Two ferrite rods to NUCLEO-H723ZG: e-CzasPL on A0, DCF77 on A1

One shared 1.65 V bias node, no coupling capacitors (replaces nucleo_225kHz_input.pdf)

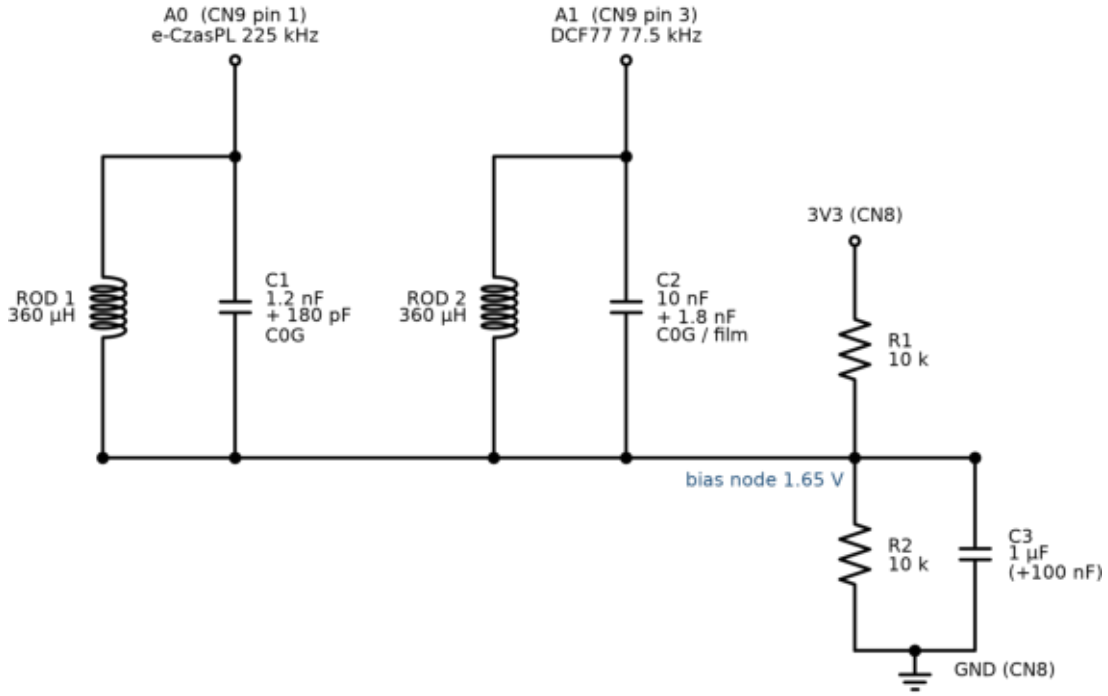
ROD 1, ROD 2: the same ferrite rod type (12 cm, about 360 µH; the rod on A0 today)
C1 = 1.2 nF + 180 pF in parallel (1.38 nF) -> 225.8 kHz (today: 1.5 nF = 216.6 kHz)
C2 = 10 nF + 1.8 nF in parallel (11.8 nF) -> 77.2 kHz (10 nF + 1.5 nF would be 78.2 kHz)
C1, C2: C0G/NP0 ceramic, polystyrene or polypropylene film (stable, low loss; not X7R)
R1, R2 = 10 k; C3 = 1 µF ceramic, optionally + 100 nF, close to the rods' bias ends

Each rod with its capacitor directly across it (a parallel tuned circuit).
Hot end of ROD 1 + C1 -> A0 (CN9 pin 1); hot end of ROD 2 + C2 -> A1 (CN9 pin 3).
Cold ends of both rods -> the bias node; 3V3 -> R1 -> bias node -> R2 -> GND; C3 bias node -> GND.
Put C1 / C2 at the board end (next to the pins); twisted pair from the rods, keep both short.

One divider and one decoupling capacitor serve both channels; the two 100 nF coupling capacitors are gone. The bias node is an AC ground (C3), so each tuned circuit sits between its pin and AC ground, and DC reaches the pin through the rod winding (a few ohms): both pins sit at 1.65 V.
Old input: the 10k/10k divider (5 k) loaded the tuned rod through 100 nF: Q about 8 instead of about 50, about 15 dB less signal at 225 kHz. Now nothing loads it (ADC sampling at 1 Msps is about 200 k).
The tuning capacitor at the pin is also the charge reservoir for the ADC's sampling capacitor.

Rods vary by several %. Tune for the highest C/N0 in the NUCLEO's CARRIER line (every 60 s):
add or remove small capacitors (47-220 pF at 225 kHz, 0.47-1 nF at 77.5 kHz). The cable adds 10-20 pF.

A ferrite rod receives best broadside (its axis at right angles to the station's direction).
From Wroclaw: Solec Kujawski (225 kHz) is about north -> ROD 1 axis east-west;
Mainflingen (DCF77) is about west -> ROD 2 axis north-south. The rods end up crossed, which also keeps them from coupling; keep them 20-30 cm apart and away from the board and power supplies.
